SERVICE BULLETIN

M-1140

2004 ELECTRICAL DIAGNOSTIC MANUAL UPDATE

To communicate a need for dealers to make corrections to the carbureted engine management sections of some Electrical Diagnostic manuals.

CKP SENSOR: DTC P0371, P0372, P0374

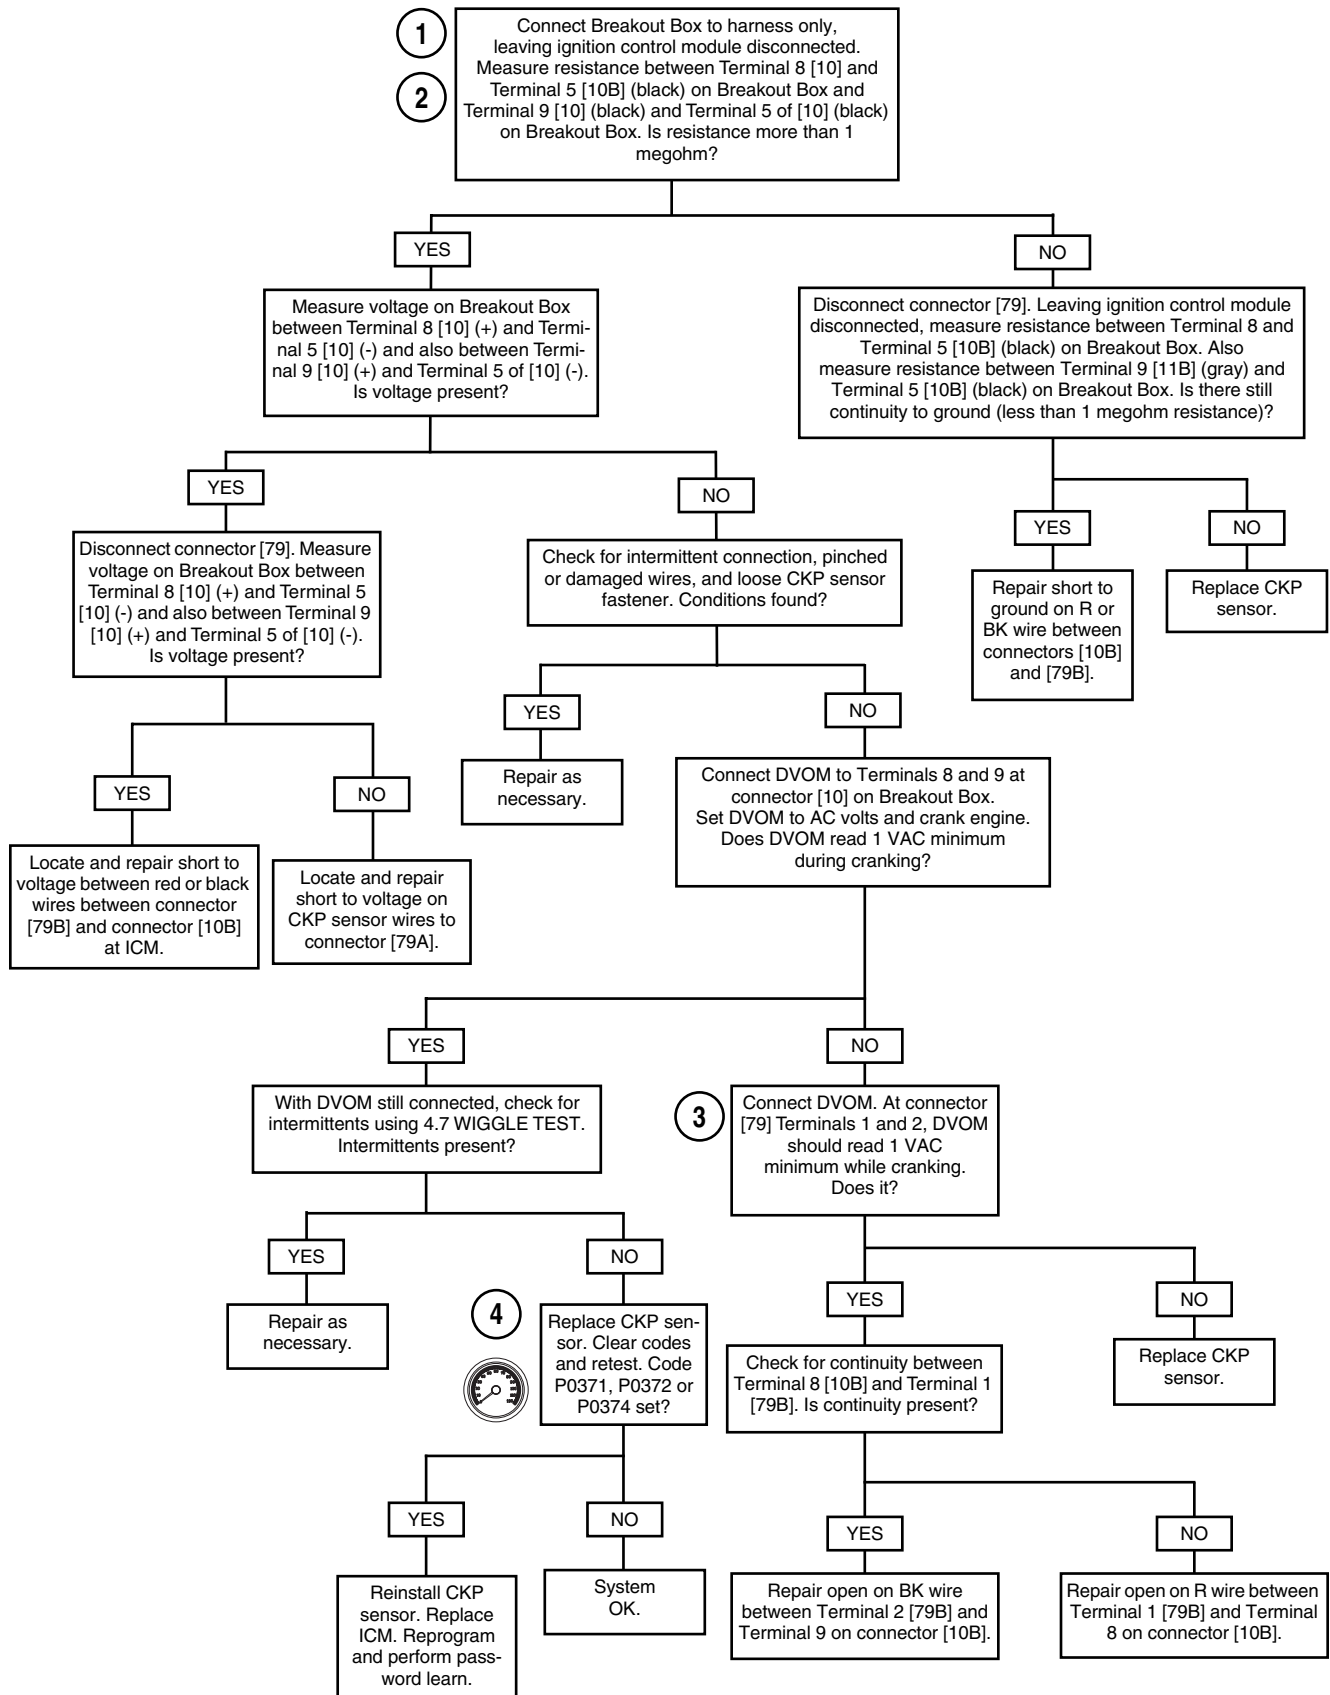
2004 carbureted model diagnostic manuals list the diagnostic trouble codes (DTCs) for the crank position sensor as P0373 and P0374. The correct DTCs for the crank position sensor on carbureted models are P0371, P0372 and P0374. DTC P0373 is not available.

A DTC P0371, P0372 and P0374 will set if the crankshaft position sensor (CKP) signal is weak, shorted or absent. The proper codes and descriptions are listed in Table 1.

- Replace CKP Sensor Chart P0373, P0374 in Section 4 of all manuals with a copy of diagnostic chart included below.
- Make notes in the main table of contents, the index and the Section 4 table of contents listing the new codes and page numbers.

Clear codes using speedometer self diagnostics. See 4.5 SPEEDOMETER SELF DIAGNOSTICS. Confirm proper operation with no check engine lamp.
